New Albany Architectural Review Board
October 12, 2026 Meeting Minutes - DRAFT

ARB-58-2026 11 S High St Exterior Modifications Certificate of Appropriateness Certificate of Appropriateness to allow exterior modifications at 11 South High Street (PID: 222-000077).
Applicant: Bill Murphy

ARB-63-2026 Apollo Coffee Signage Certificate of Appropriateness
Certificate of Appropriateness for a new sign for Apollo Coffee at 45 N. High Street (PID: 222-000018).
Applicant: Jacob Rovito

ARB-64-2026 Harvest Pizza Signage Certificate of Appropriateness
Certificate of Appropriateness to allow for new signage at 24 E. Main Street (PID: 222-000043).
Applicant: Jeff Pevec

Apollo Coffee Projecting Sign (1)

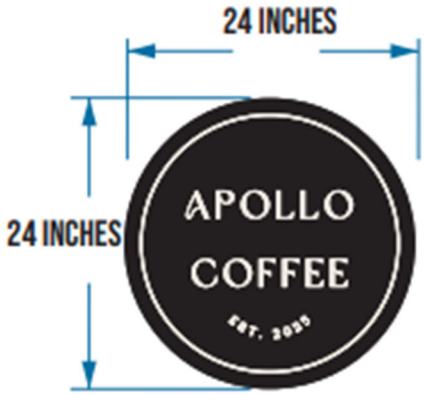
Board Member Brown discussed the previously approved ADA ramp and whether it will interfere with the bottom of the sign.

Mr. Rovito explained that the elevation of the door is higher than it appears on the rendering and the sign is over a flower bed.

Board Member Strahler asked what was previously approved because he thought it included a retaining wall.

Planner I Blackburn confirmed Board Member Strahler's recollection of a retaining wall, she explained that the prior approval included the wall and a rail.

- The sign will be made of HDU panel with acrylic letters, which are permitted sign materials.
- The applicant has stated that the sign will still meet the required 8-foot clearance with the addition of the recently approved ADA ramp. <u>Staff recommends a condition of approval that the sign be located on the other side of the entrance if the clearance cannot be met with the addition of the ramp, subject to staff approval (*condition #1*).</u>

1. If the sign clearance cannot be met with the addition of the ADA ramp, the sign shall be moved to the other side of the main entrance to meet code, subject to staff approval.
